**JUSTIFICATION LETTER FOR MINOR AMENDMENT TO SITE DEVELOPMENT PLAN
APPROVAL PRIOR TO EFFECTIVE DATE OF THE IDO.**

DRB No.: 1011638
IDO Zoning: NR-BP
Legal Description: Lot 22-A, Block No. 8, original Townsite of Westland, being a replat of Lot 22, Block 8 within Town of Atrisco Grant, Bernalillo County.

L&C TRANSPORT OFFICE AND SHOP

MINOR AMENDMENT TO SITE DEVELOPMENT PLAN
APPROVED PRIOR TO EFFECTIVE DATE OF IDO

1 Site Plan
1" = 20'-0"

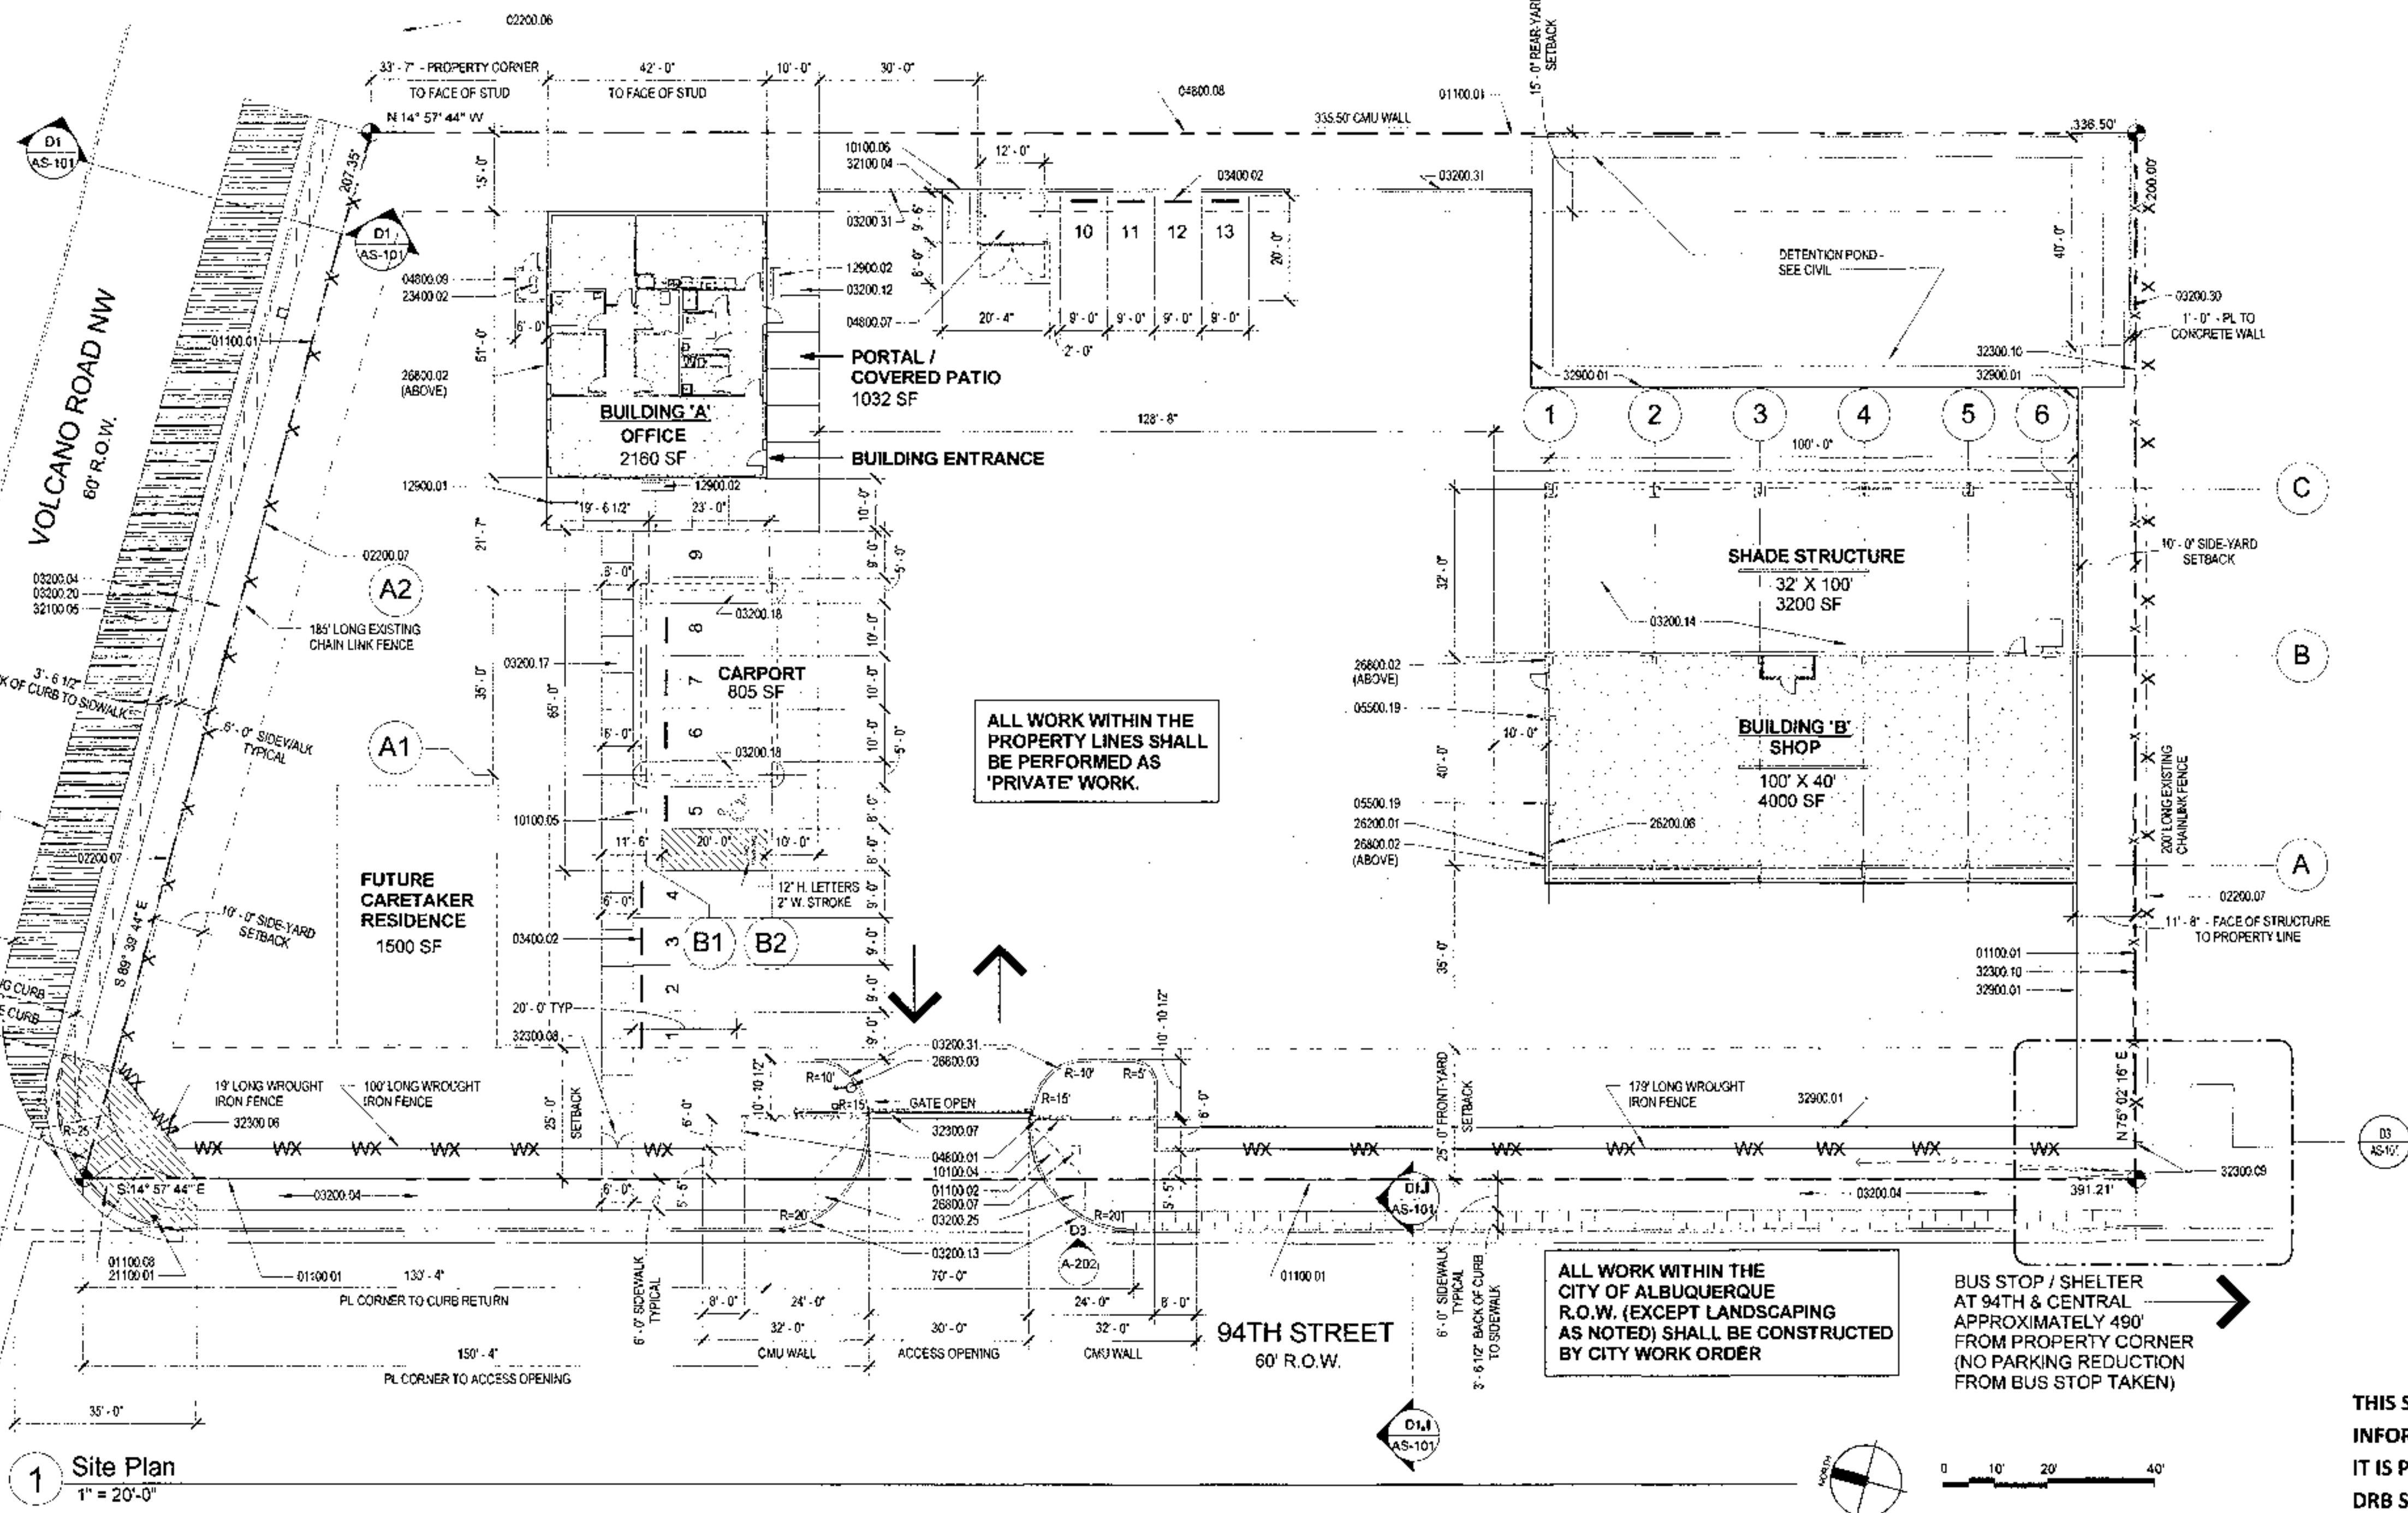
The original DRB Submittal identifies a driveway into the site along 94th Street. During construction of 94th Street, as part of the Work Order associated with the project, the elevation of 94th Street and the driveway into the site was raised at the direction of the City Engineer. Being that the buildings were already constructed, it creates an unworkable condition whereby the semi-truck-car trailers in which this project is designed for are unable to drive into the site as they bottom out at the driveway and are therefore unable to access-egress the site.

SITE PLAN

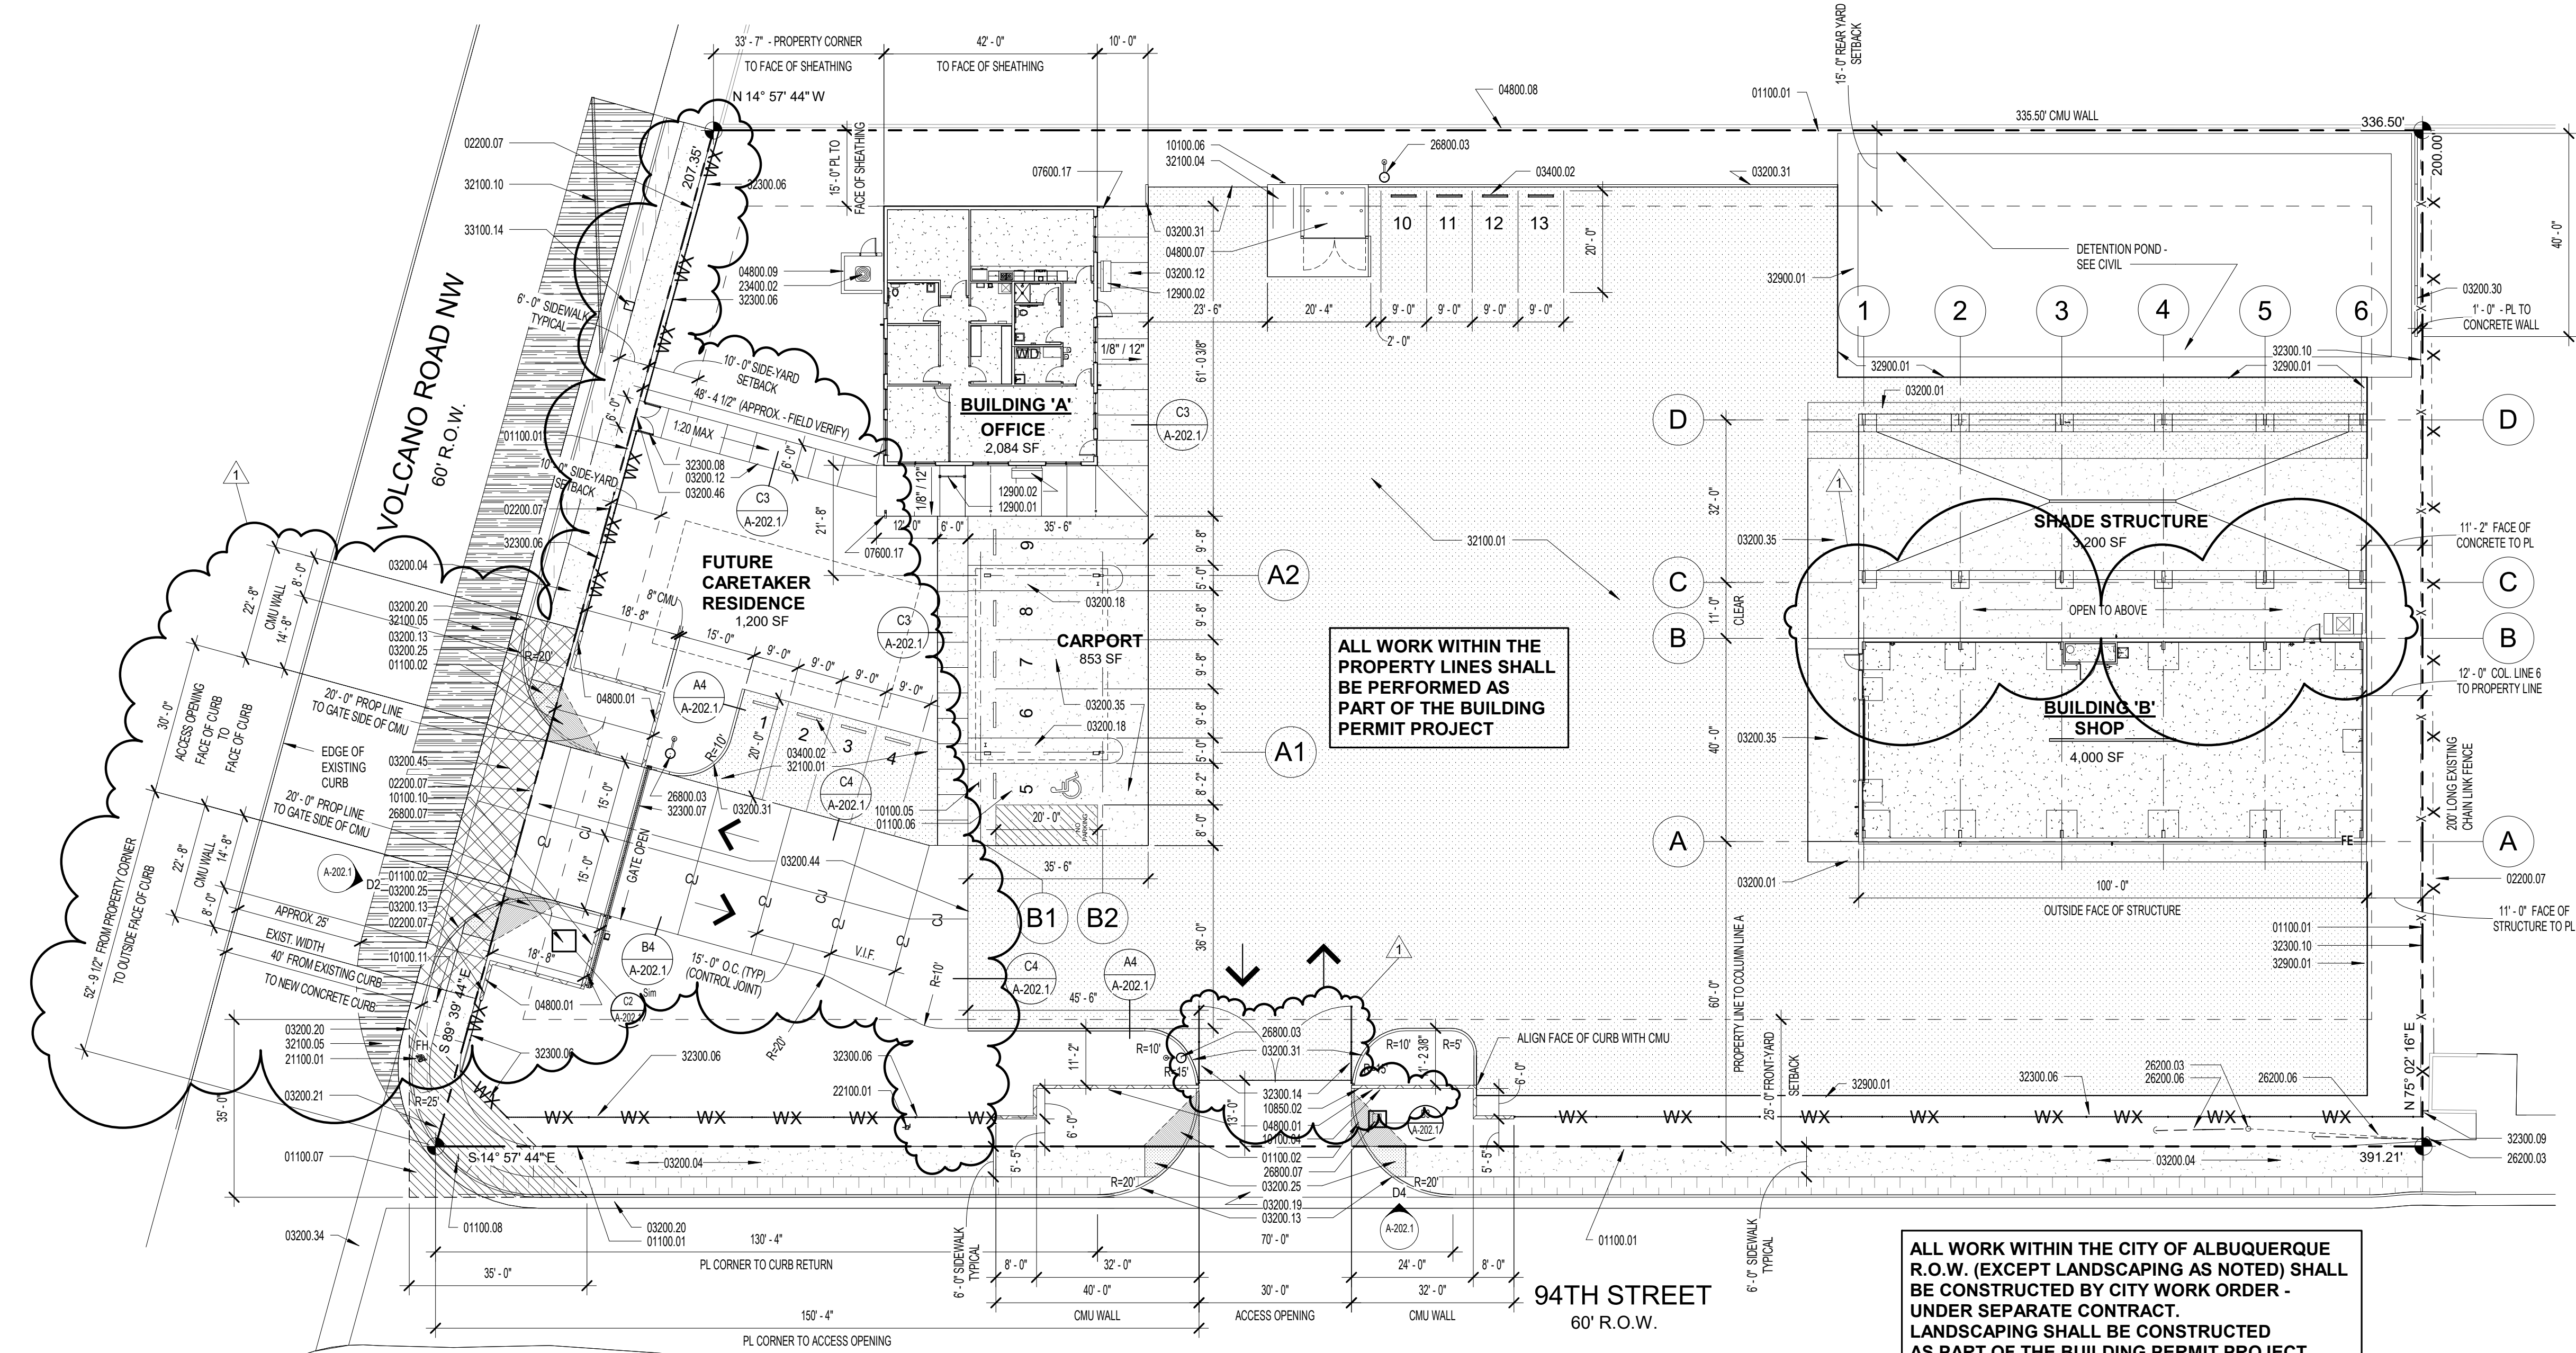
DESCRIPTION:
THIS MINOR AMENDMENT IS FOR THE CONSTRUCTION OF AN ADDITIONAL DRIVEWAY
ENTRANCE INTO THE PROPERTY, RELOCATION OF THE PEDESTRIAN GATE AND SIDEWALK
INTO THE PROPERTY, AND MINOR CHANGES TO THE LANDSCAPING TO ACCOMMODATE THE
NEW DRIVEWAY.

- AN ADDITIONAL DRIVEWAY / CURB CUT WILL BE INSTALLED ON VOLCANO RD. NW.
AN AUTOMATIC SLIDING GATE SHALL BE INSTALLED AT THAT ENTRANCE. THE
ENTRANCE GATE ON 94TH ST. WILL BE A MANUAL SWING DOUBLE GATE.
- PEDESTRIAN ACCESS AND GATE WILL BE FROM VOLCANO RD. NW.
- ALL FENCING ALONG VOLCANO AND 94TH ST. WILL BE WROUGHT IRON.
MASONRY WALLS WILL BE INSTALLED ON EACH SIDE OF THE VEHICLE GATES.
- FOUR INTERIOR PARKING SPACES WILL BE LOCATED NORTH OF THE HANDICAP
PARKING SPACE.
- THE SHADE STRUCTURE IS A SEPARATE STRUCTURE FROM THE SHOP BUILDING PER
THE APPROVED BUILDING PERMIT SET.

SITE DETAILS / SIGNAGE

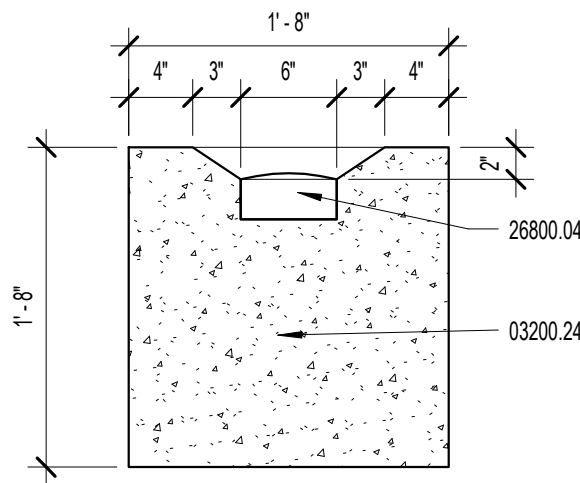
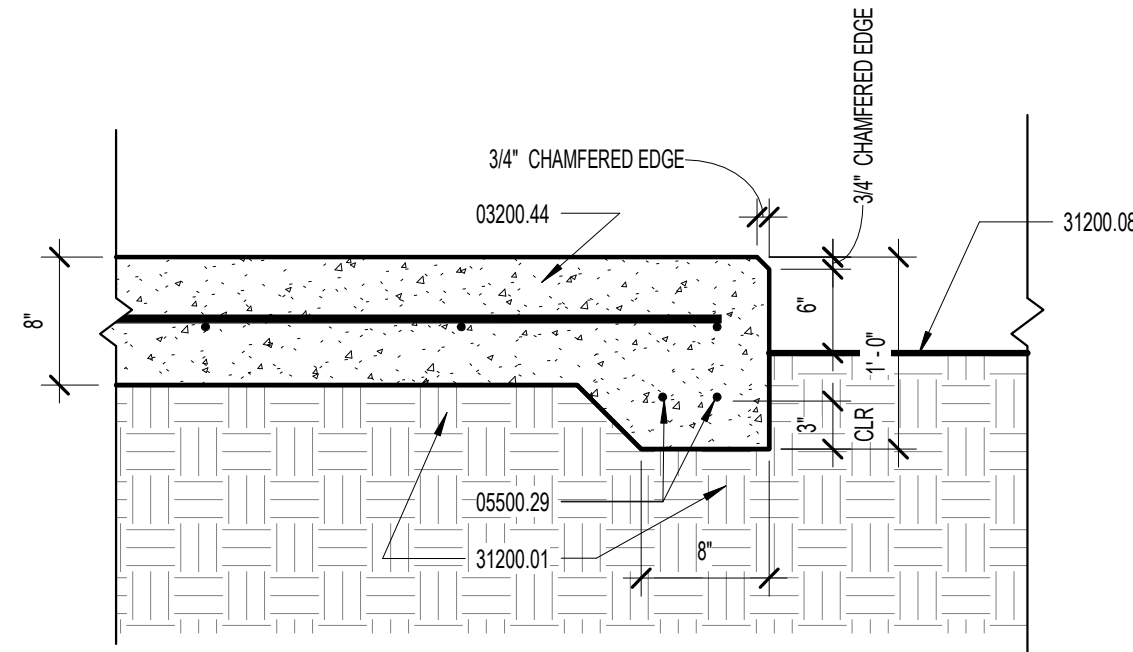
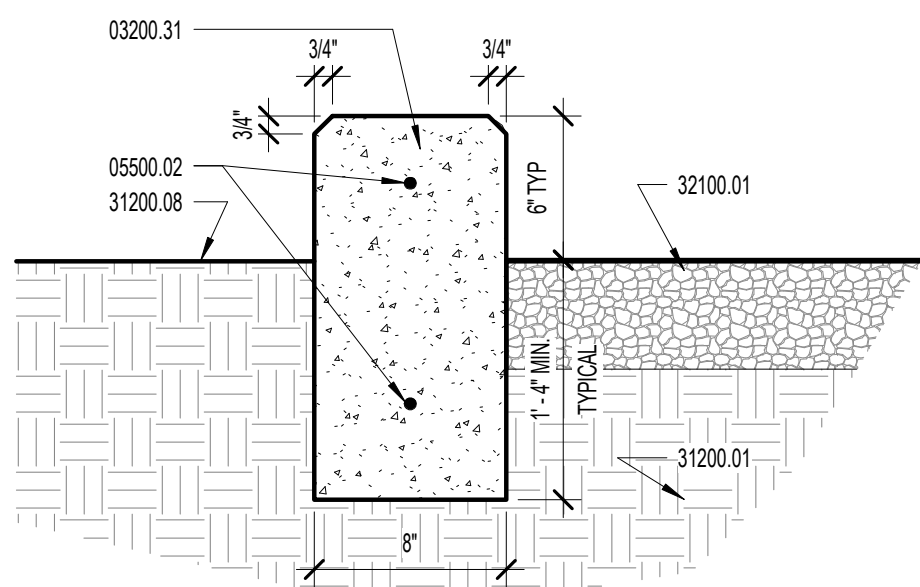
PROPOSED CHANGES PER THE MINOR AMENDMENT TO SITE DEVELOPMENT PLAN INDICATED BY THIS SHEET

- NEW DETAILS FOR NEW CONCRETE DRIVE
- REVISED PRE-CAST CONCRETE ADDRESS SIGN AND NUMBER.
